# Service Bulletin

**Bulletin No:** 2003-1-29

**Subject:** Hood Vent Foam (PTO-Side)

All 2003 Mountain Cat 570's

**Fig. 1**

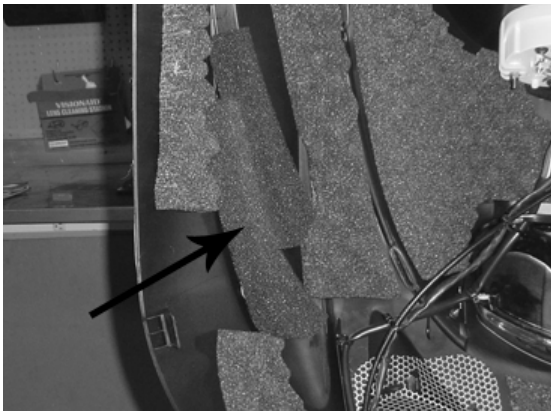
**Condition:** Hood Vent Foam (p/n 0617-426) located on the PTO-side of the hood was designed to prevent snow from entering the clutch area. It has been determined, however, that the foam prevents the air from the engine fan to escape through the air-out duct. This condition may cause the air-out duct to overheat resulting in possible heat damage to the duct.

**Solution:** Remove Hood Vent Foam (p/n 0617-426). See Fig. 1 for the location of the foam to be removed. Please advise all owners of an affected snowmobile concerning this issue.
